RE: Horse Heaven Wind Farm Draft Environmental Impact Statement (Docket Number EF-210011)

This comment letter is submitted on behalf of Audubon Washington (“Audubon”), a state field office of the National Audubon Society, in response to the Horse Heaven Wind Farm project (“Project”) Draft Environmental Impact Statement (“DEIS”).

Figure 1. Arid Lands Initiative Core Areas and Linkages (USFWS 2015).

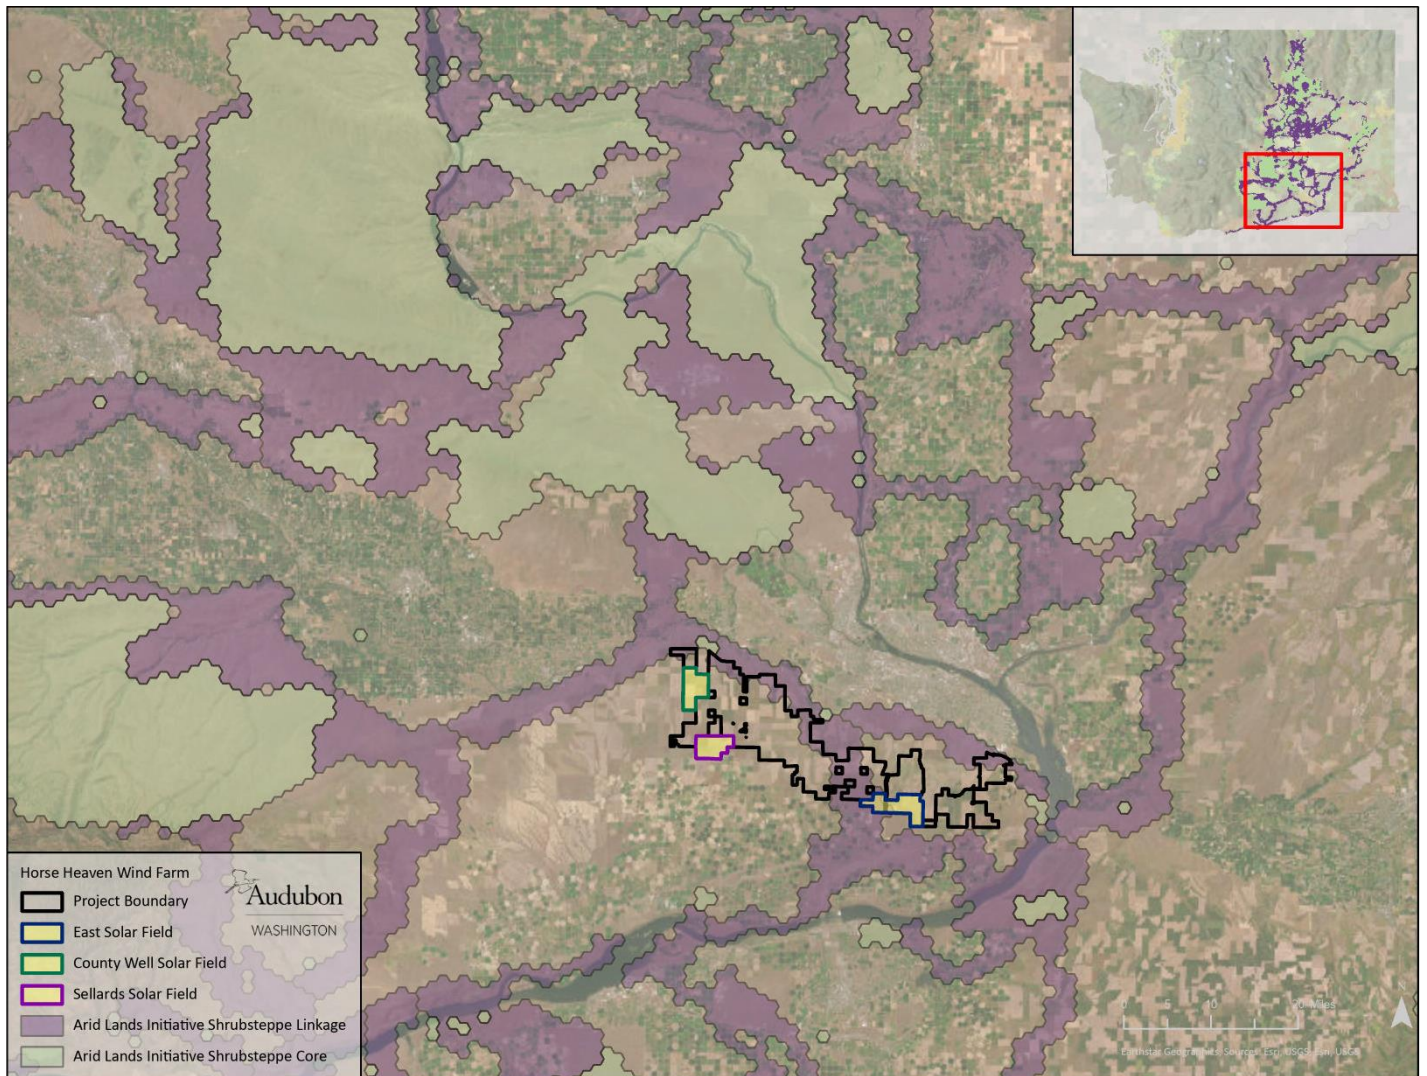
Based on the location of the Project micro-siting corridors and proposed east solar field in *Section 2.1.1 Figure 2.2* the Project will disrupt east-west and north-south landscape connectivity and Ferruginous Hawk foraging habitat within the Arid Lands Initiative Fourmile Canyon Primary Linkage Area (PLA #36) (USFWS 2015) (Figure 1).

Figure 2. Ferruginous Hawk Nest Density (source: WDFW).

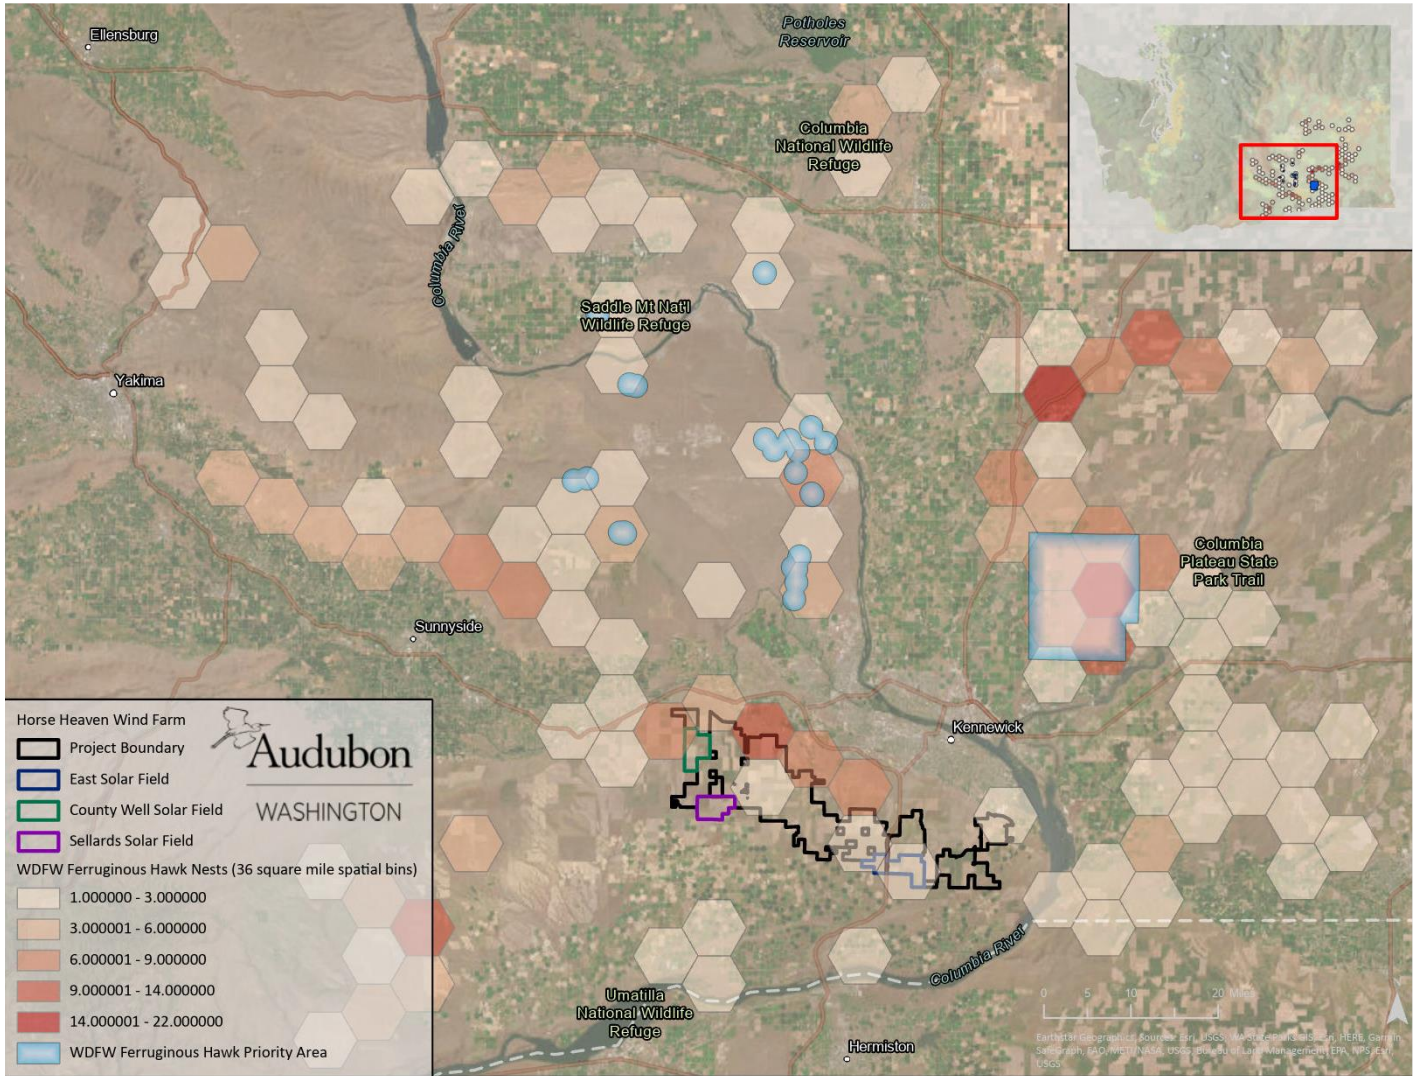
Analysis Issue 2B: Ferruginous Hawk. Ferruginous Hawk is a State Endangered species that is suffering steep declines, both locally in Benton and Franklin Counties and state-wide (Hayes and Watson 2021). *In Section 4.6.2.4 Special Status Species*, the DEIS states that “*PHS data document 41 Ferruginous Hawk nests within 2 miles of the Lease Boundary, including 10 within the Lease Boundary (WDFW 2022a).*” Breeding Ferruginous Hawks are sensitive to the density of wind turbines. A recent study of *Buteo* hawk nest success and post-fledgling survival in the Columbia Plateau Ecoregion observed decreased nest success for Ferruginous Hawks and lower *Buteo* hawk fledgling survival in association with greater wind turbine densities (Kolar and Becher 2016). According to Ferruginous Hawk nest data we acquired from WDFW, the Project is in an area of relatively high importance for Ferruginous Hawk nesting activity in Washington State, warranting careful consideration of potential impacts to the statewide population (Figure 2).

Figure 3. Proportion of Project Lease Boundary and habitat types within 6-miles (home range) of Ferruginous Hawk nests. Only the SW corner is outside the Hawk's home range.

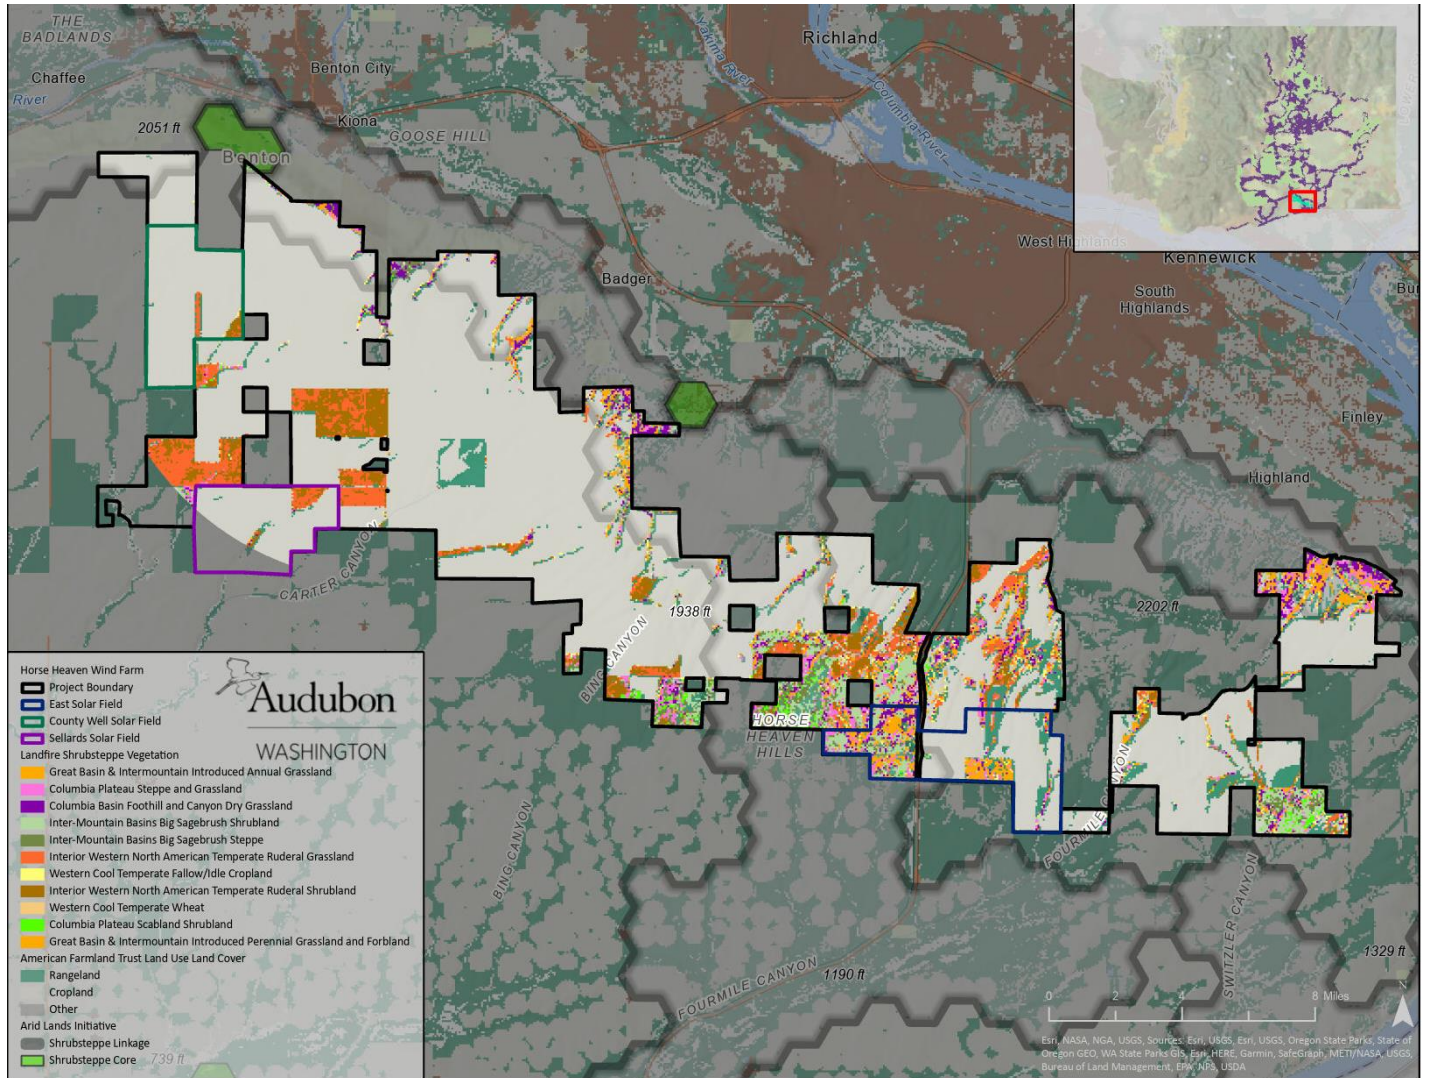
The DEIS calculates potential direct and indirect habitat loss based on a Ferruginous Hawk 2-mile core habitat and 6-mile range habitat for documented nest locations. There appears to be an issue with this analysis. For reasons that are unclear, the DEIS limits the analysis to just two active nests that were observed by the Applicant during field surveys, rather than all documented nests in the vicinity. According to the state Ferruginous Hawk species expert, Ferruginous Hawk may reoccupy vacant nest territories after many years of absence, and protection of nesting territory viability, including unoccupied nest territories, is a core component of species recovery in the state (J. Watson, pers. communication). The DEIS estimate of potential direct loss of ~7,800 acres of Ferruginous Hawk range habitat and indirect loss of ~42,849 acres of range habitat is based on just two nests and vastly underestimates potential impacts to the species. Based on telemetry data in Washington and Oregon, the average home range of a nesting pair is ~10km (6.2 miles) radius from the nest (unpublished data reference by J. Watson in Jansen et al. 2022). All nests within this radius of the project should be considered in the Applicant's calculation of direct and indirect loss. According to our analysis, there are 51 documented nest sites within 6 miles of the lease boundary, which would result in impacts to Ferruginous Hawk core and range habitat across the majority of the Project Lease Boundary area (Figure 3), including native shrub-steppe habitat within the Fourmile Canyon Linkage area.

Figure 4a. Sixty-nine of the 244 proposed turbines in Layout Option 1 are within 2 miles of Ferruginous Hawk nests.

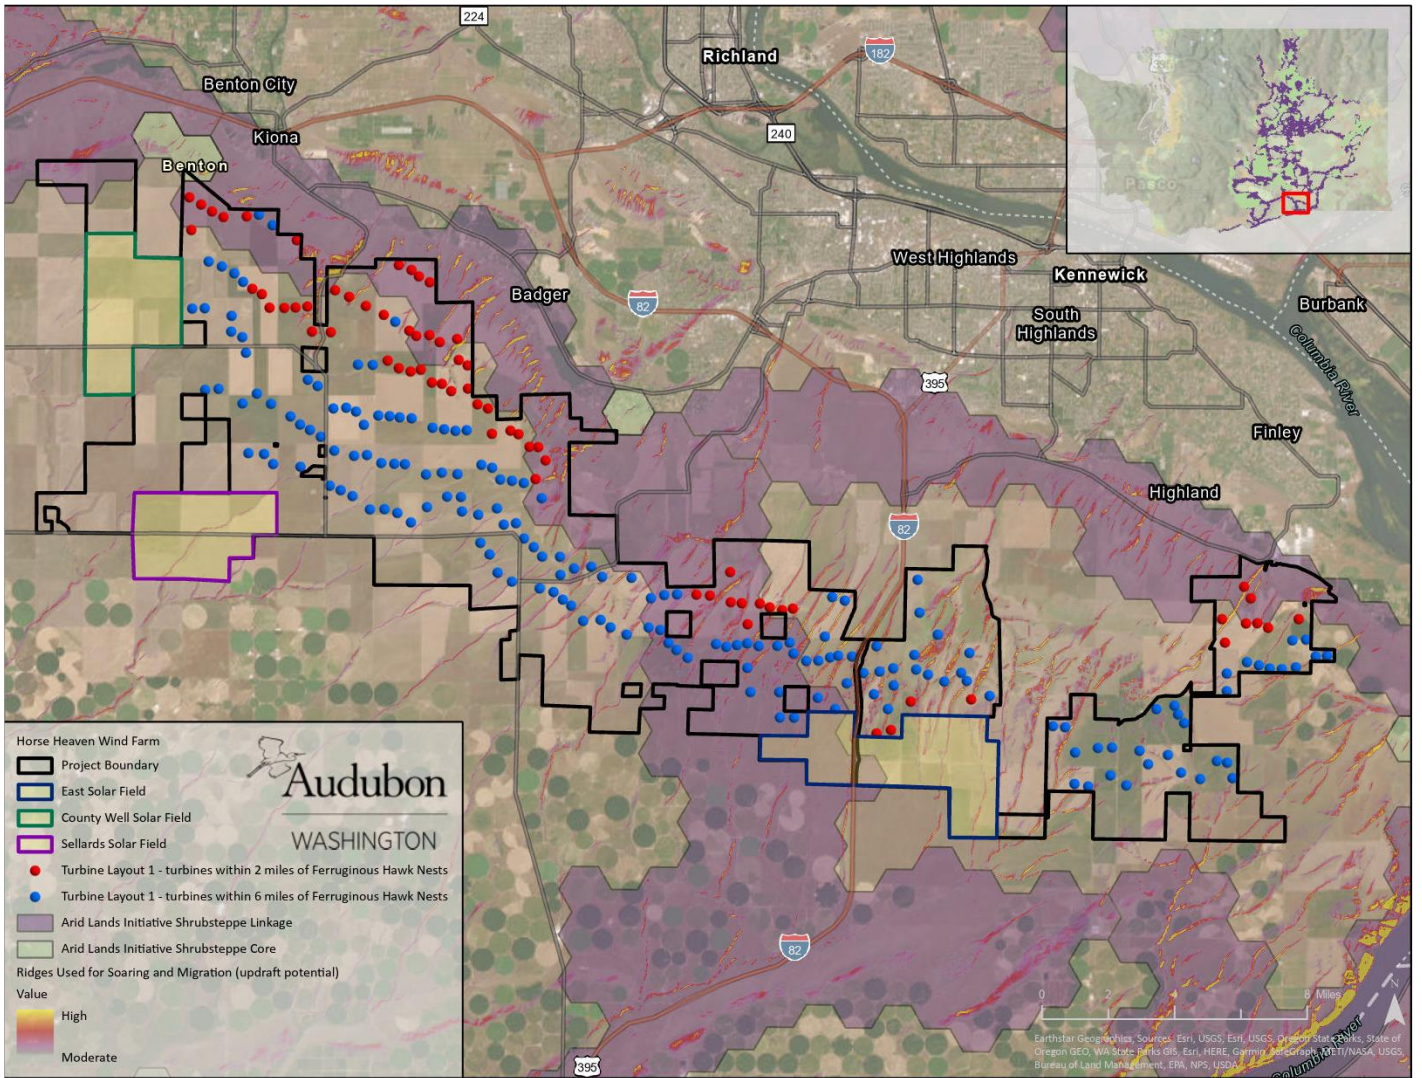
- Eliminating turbines within a 2-mile radius of Ferruginous Hawk nests and between Sheep and Webber Canyons;
- Reducing the density of turbines in the Fourmile Canyon linkage area (e.g., Figure 4a, 4b);
- Designing the East Solar Field to eliminate the creation of a pinch point for wildlife connectivity, and;
- Conducting habitat restoration within the Fourmile Canyon linkage area.
